Authors' response to reviewer 3

Figure 1: Irregular wave frequency range $T_p = 9s$

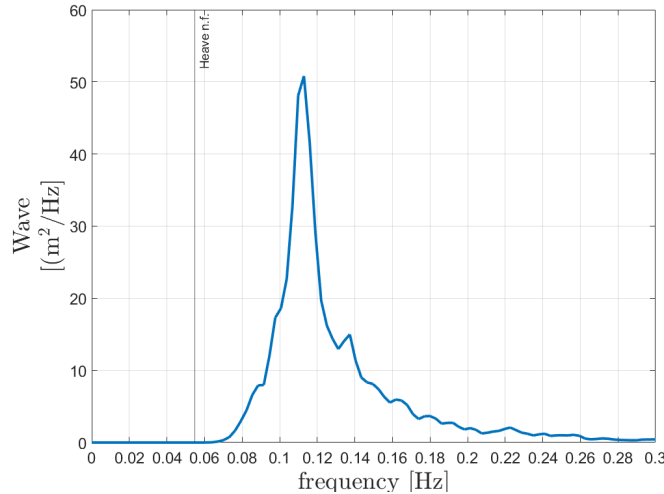
Table 10: Is there concern with the coalescence of the heave natural frequency for Activefloat with waves?

The heave natural period is much higher than the peak wave period (T_p) in the Gran Canaria islands which is between 6 s at normal operations and 9 s at extreme conditions, hence the heave natural frequency lies outside of the wave frequency range. We have not seen any concerning responses in any load case, and we believe there is no coalescence. Figure 1 shows Activefloat's heave natural frequency with the vertical line, and the wave frequency range for $T_p = 9s$.
